FINAL MONITORING REPORT
2022 (Year 4)

HERON STREAM AND WETLAND MITIGATION SITE

Response to Monitoring Year 3 (2023) DMS Comments

Heron Stream and Wetland Mitigation Site (DMS #100014)
Cape Fear River Basin 03030002, Alamance County
Contract No. 7192

FIGURE
2B

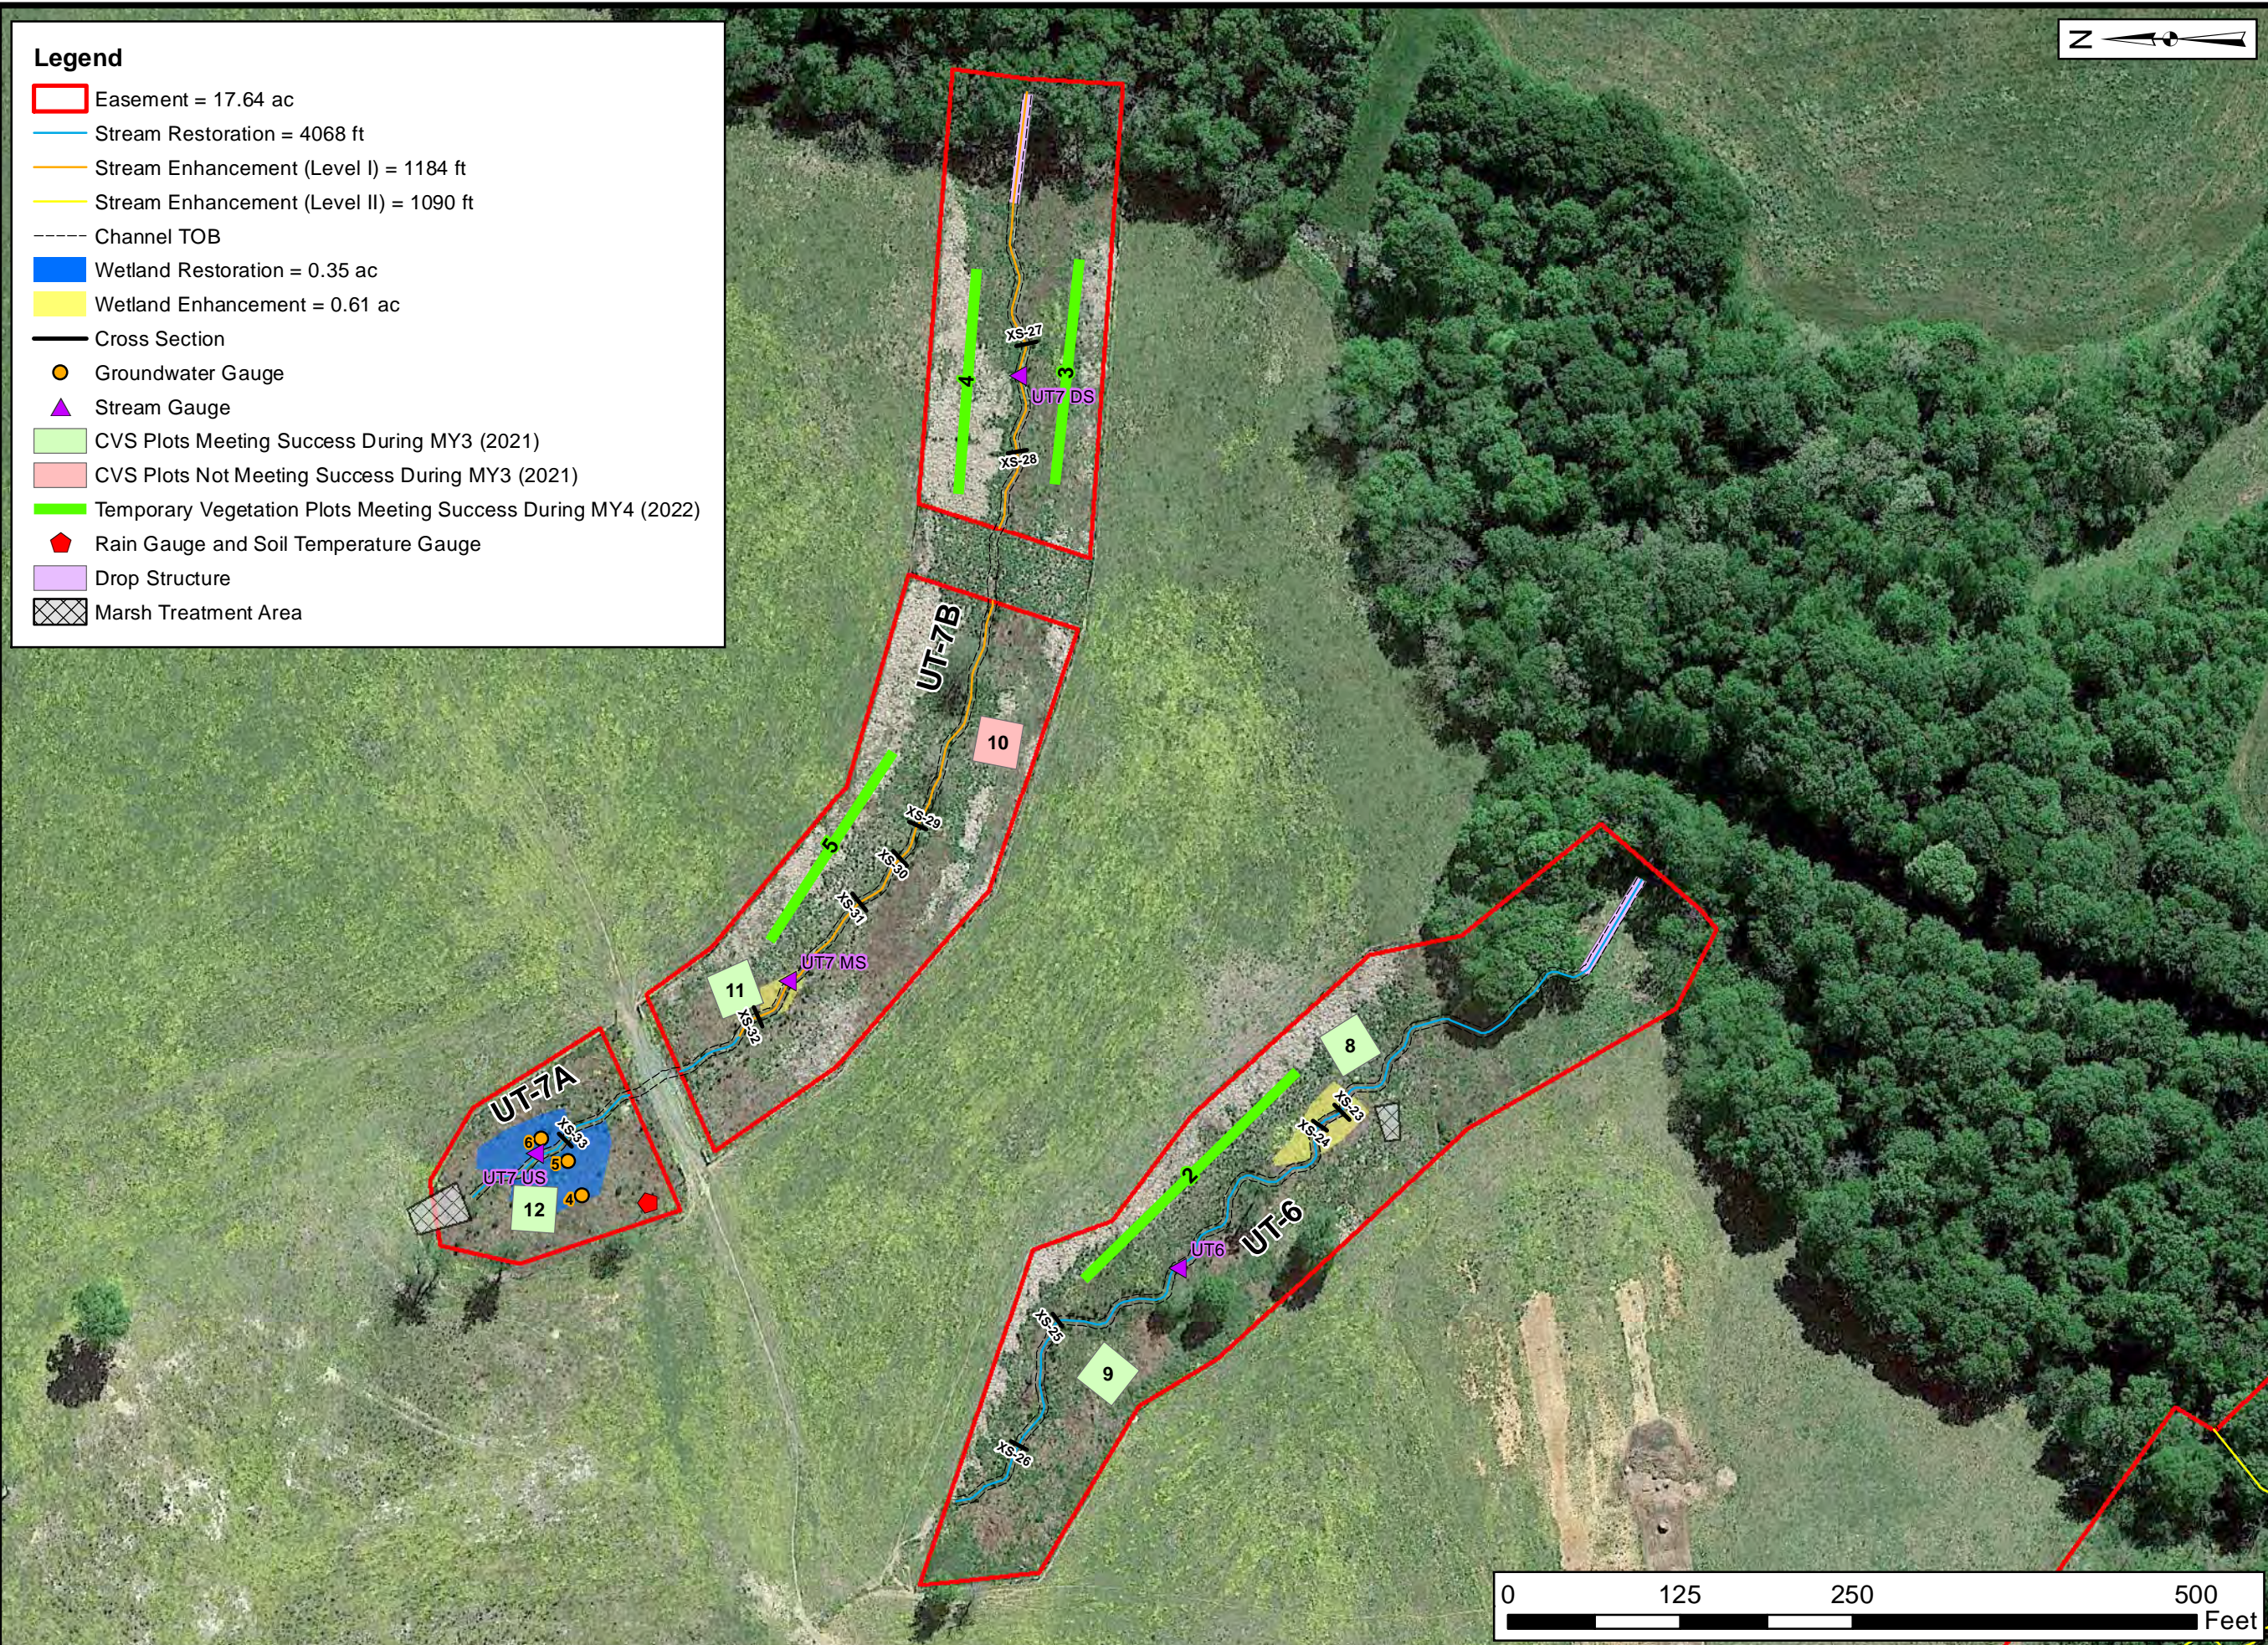
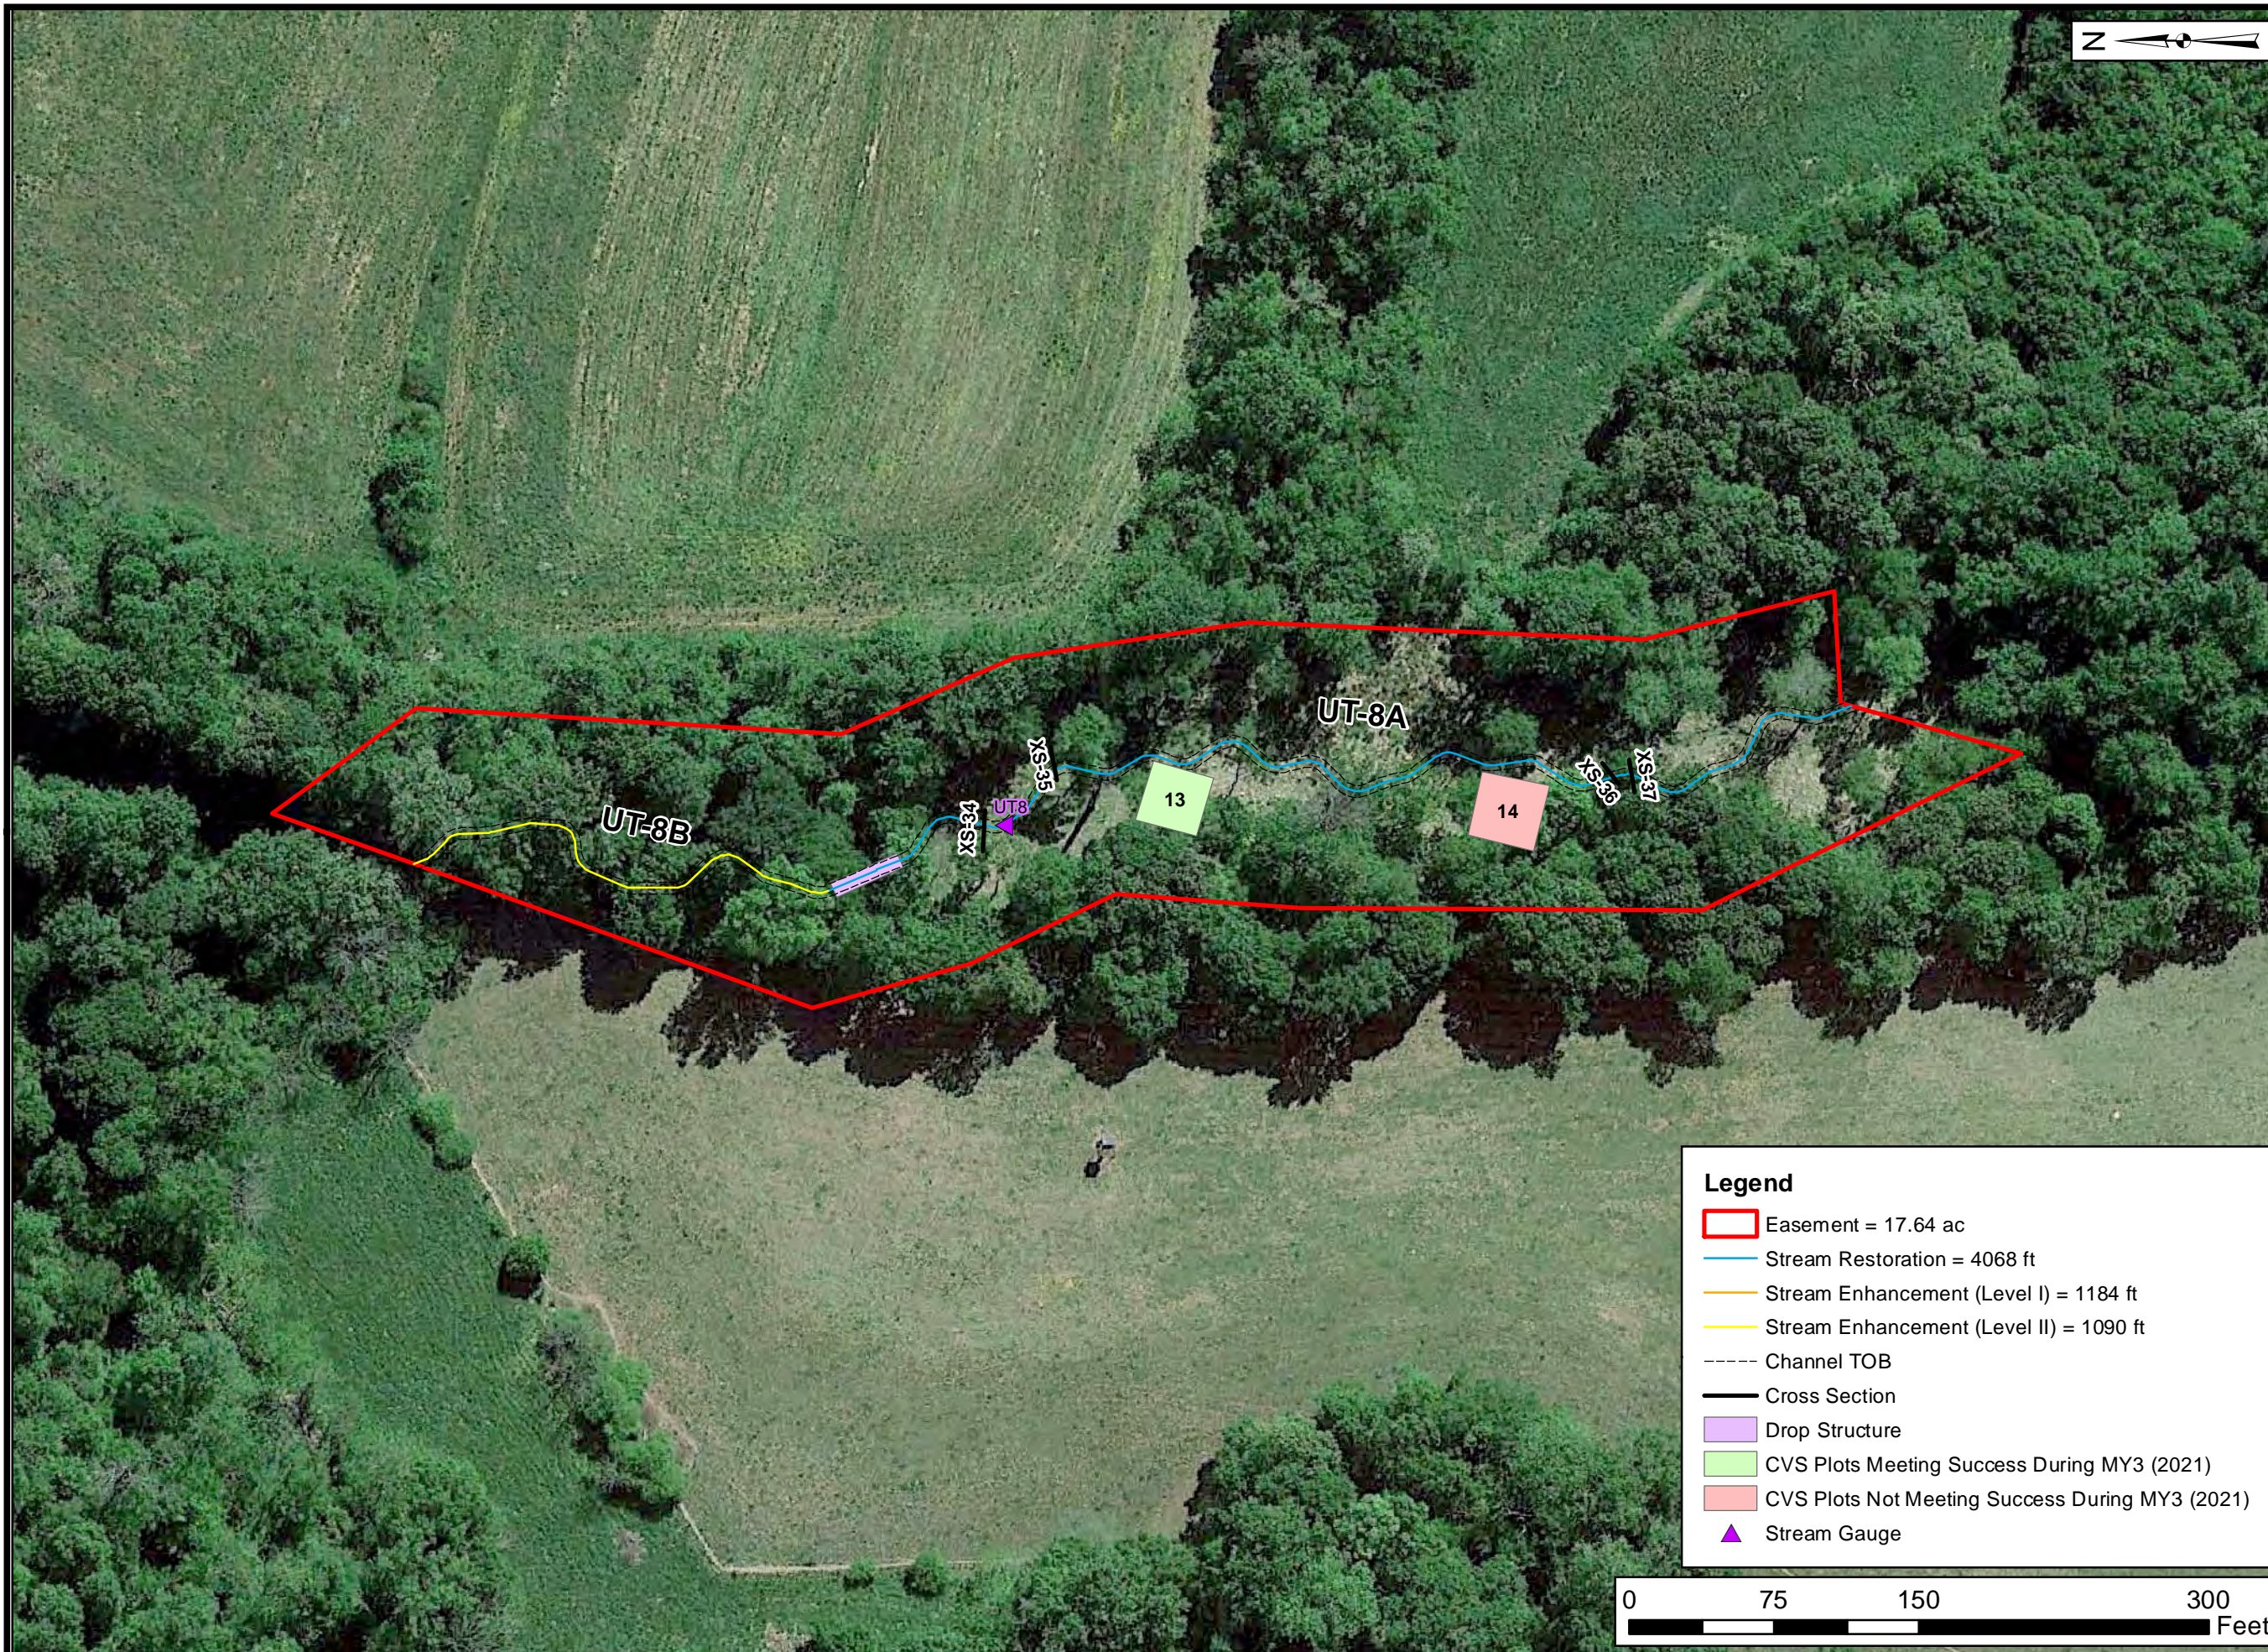
1. Page 9, Vegetation Summary states that the supplemental planted areas are shown on Figures 2A-C, but those do not appear. Remove from narrative (since they were in previous report) or show on CCPV.

Response: The supplemental planting narrative, describing the effort completed in 2021, was removed from the report.
2. Label flow gages on CCPV?
Response: Flow gauges have been labeled on Figures 2A-D.
